HORSHAM DISTRICT COUNCIL CONSULTATION

TO:	Horsham District Council – Planning Dept
LOCATION:	New Place Nurseries London Road Pulborough West Sussex
DESCRIPTION:	Reserved Matters application pursuant to Outline Planning Consent DC/21/2321, as varied by application DC/24/1204. The Reserved Matters comprise details of 160 no dwellings, associated internal access roads, parking and landscaping for areas east of the right of way. Details of appearance, landscaping, layout and scale to be considered.
REFERENCE:	DC/24/1676
RE-CONSULT:	1 st set of comments in black 2 nd set of comments in blue 3 rd set of comments in green 4 th set of comments in purple
RECOMMENDATION:	Objection / More Information / Modification Objection / More Information / Modification Objection Objection / Modification

4th set of comments

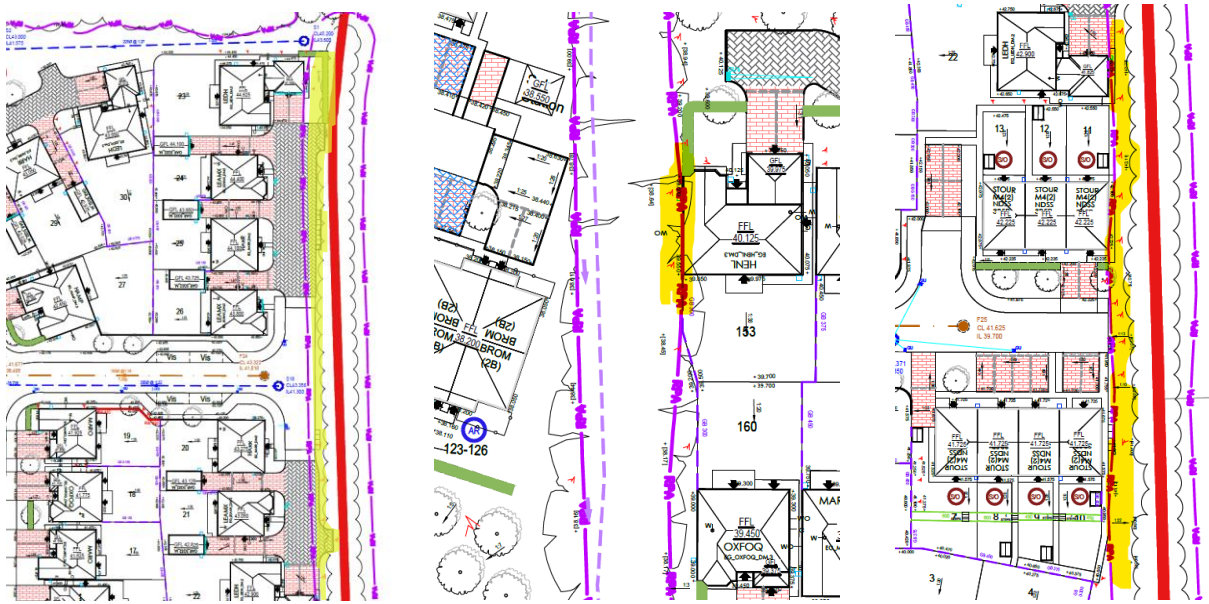
While it is accepted that the loss of the central tree belt could potentially be mitigated and compensated through the submission of a robust methodology for replacement and compensatory measures, the eastern boundary does not benefit from the same level of flexibility. Its retention and enhancement, particularly given its position and function as a buffer between the proposed built form and the countryside, are critical to mitigating the adverse effects identified within the LVIA at outline stage.

This proposed relationship is not considered to be acceptable and cannot be supported on landscape and visual amenity grounds.

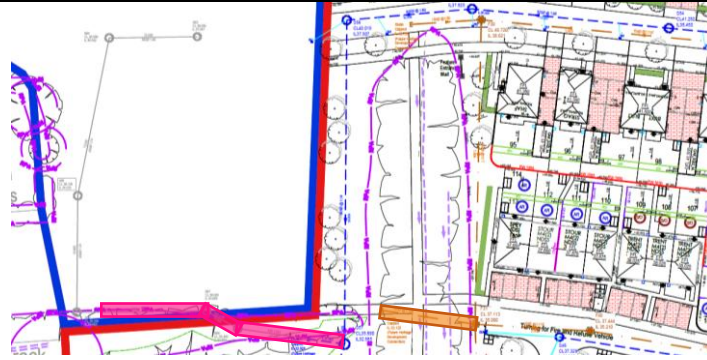
3. No changes have been made in order to avoid RPA encroachment throughout the scheme, and further, proposals continue to not deliver the LVIA identified mitigation measure of retaining existing vegetation, nor the objective of providing a '*Soft development edge and enhanced boundary planting*'. The eastern boundary remains of key concern as the level of RPA encroachment places this treeline at risk of decline and future loss significantly undermining the proposed mitigation strategy, reviewed and accepted at outline stage. Please see examples highlighted in yellow below, noting that the encroachment will be considerably larger on account of necessary earthworks. We continue to request that built form be pulled west to avoid RPAs and create opportunities for the enhancement of the tree belt to be delivered, as identified within the LVIA.

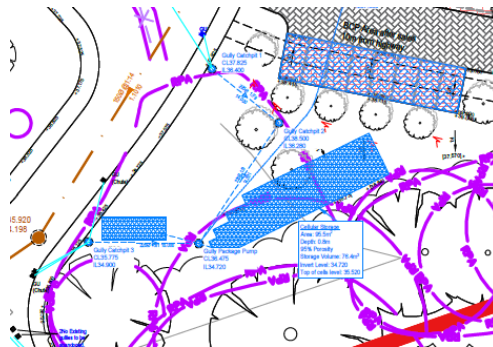
4. An updated AIA and Tree Protection Plan (TPP) has not been provided. This must be submitted and reflect proposed earthworks and drainage proposals in order to accurately demonstrate the level of RPA encroachment, loss and removal of existing trees and vegetation.
5. In addition, we continue to request that layout is reviewed in order to avoid unnecessary loss of green infrastructure, as demonstrated by the submitted coordinated overlay plan. For example:
 - a. To minimise loss or deterioration to Category A G28, please modify foul run (orange, below) to align with proposed footpaths.

- b. G33 is noted to be retained in all plans except from the TPP. In any case, the proposed drainage run continues to give rise to unnecessary loss (pink, above). Please adjust the run to avoid this treeline, as previously requested, and amend the TPP to reflect retention in correlation with all other plans. If the loss of this feature is unavoidable, all plans must be amended to reflect the loss and replacement trees proposed.
- c. An attenuation crate is proposed within the RPA's of the southern treeline, compounding its deterioration. Please remove attenuation crate from the RPAs to minimise adverse effects to the landscape character and amenity of the area. This location is the gateway to the development and it is imperative that the existing landscape feature is retained.

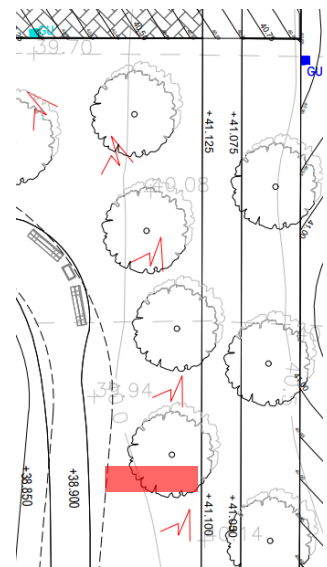
The levels plan indicates overly steep gradients in places, significant drops and retaining wall heights. Which reflects how the scheme is imposing itself into the site rather than work with the existing and prevailing topography. While it is recognised that the permission is for the delivery of up to 160 dwellings (within this parcel, excluding the 10 units in the western parcel), and that some of these issues will be unavoidable in places, further consideration should be given to the following points:

7. Where embankments remain too steep, proposals for slope stabilisation methods are required. These should be provided as a typical detail and marked on a plan where required. As an example, the area highlighted in red, indicates a 1:2 slope but no method of stabilisation. Further, the footpath is adjacent to a significant drop with a steep slope in combination with the attenuation basin below. It is highly likely that future residents will request railings or some sort of barrier, even after a safety risk assessment is carried out and this arrangement is considered acceptable. We recommend the levels to be amended to reflect a gentler slope or both railings or deterrent planting and bank stabilisation measures added to the proposals.

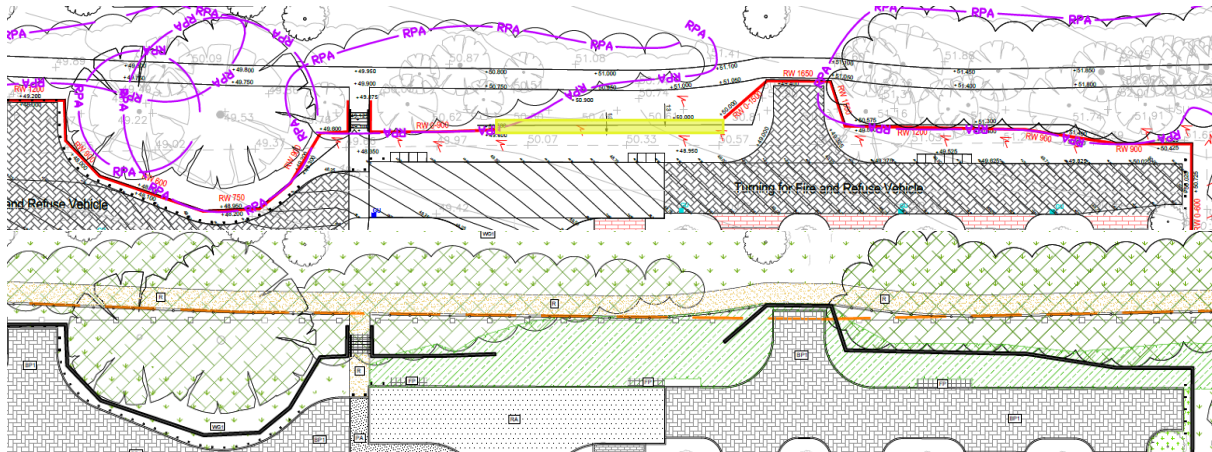
9. Some areas within the northeastern part of the scheme remain unresolved and are cause for concern. For example,
- Post and rail fence is now proposed to the south of the PRoW, which is welcomed, however this does not appear compliant with relevant standards, given the large gaps and the proposed drop in height. Please review.
 - Clarification on the heavy black line highlighted in yellow is required.
 - Level changes are indicated for the PRoW itself, however this would suggest earthworks within the RPA of the existing treeline.
 - The roadside gradients are overly steep and no method of slope stabilisation is proposed.

The realignment of the retaining wall to follow to the outline of the road (inclusive of curved edges for amenity value) is therefore requested. This will reduce overly steep banks but also reduce the encroachment and disturbance to the rooting medium of the existing treeline.

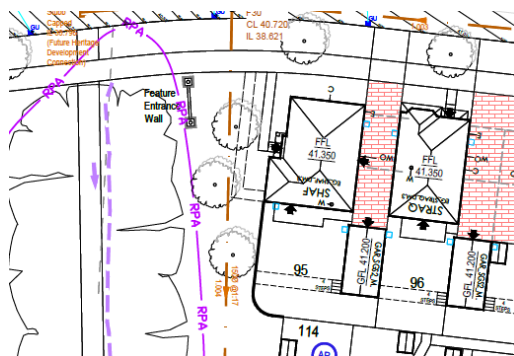
- As per point 5f and as previously requested, tree species and sizes must be labelled or identified within landscape proposals in order to assess suitability.
- Please relocate the proposed trees below to fall outside the foul run easement zone.

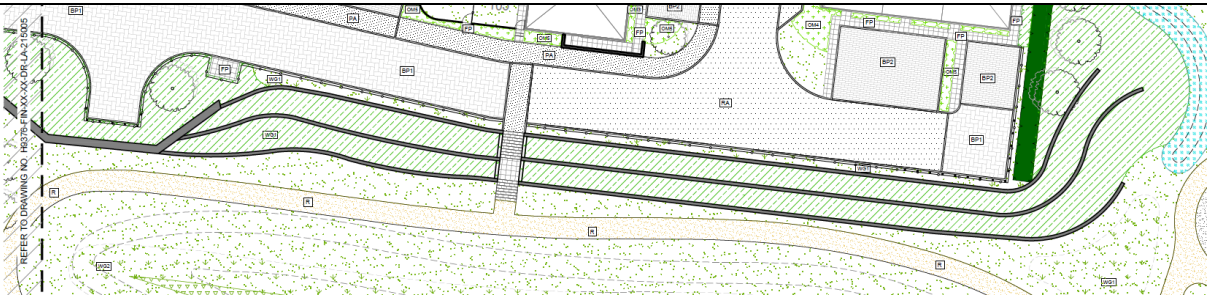
- Feature and/or tree planting is requested within the retaining walls, as opposed to native shrub planting, to provide further amenity value and soften the engineered appearance. In addition, the appearance and proposed material of the retaining wall must also be provided.

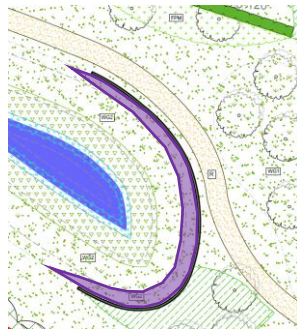
13. The newly proposed retaining walls within the attenuation basins create an overly engineered appearance, thus softening is required. Please include planting in front of the retaining walls, such as the example below highlighted in purple, for amenity value and safety purposes.
